IN THE DRAWINGS

Annotated Sheet

FIGURE 3

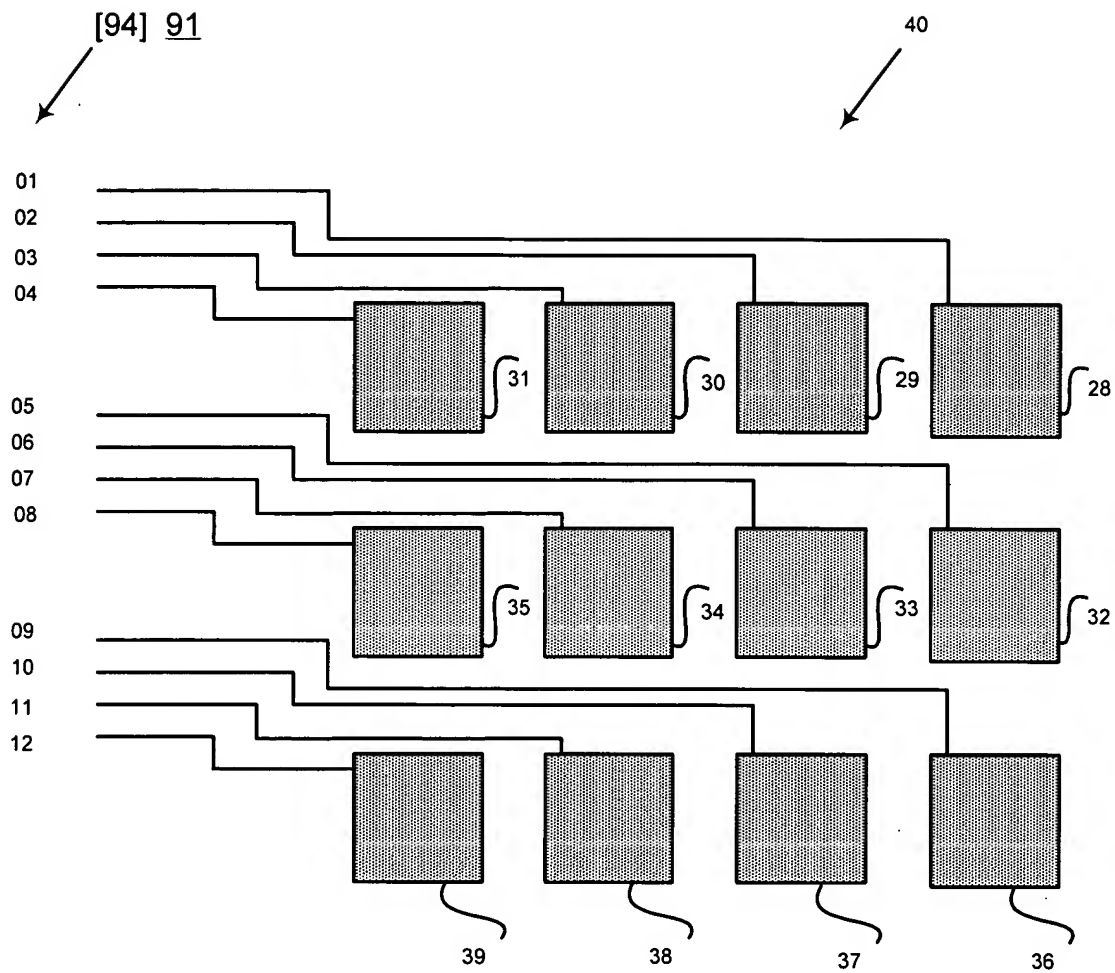
The enclosed replacement drawing sheet is intended to replace the original sheet of Figure 3. In Figure 3, applicant corrects a typo in the part number of the I/O addresses as shown in the enclosed mark up of Figure 3 as indicated in the enclosed annotated drawing sheet. Figure 6 and paragraph 0026 of the published specification support the I/O addresses should be part number 91.
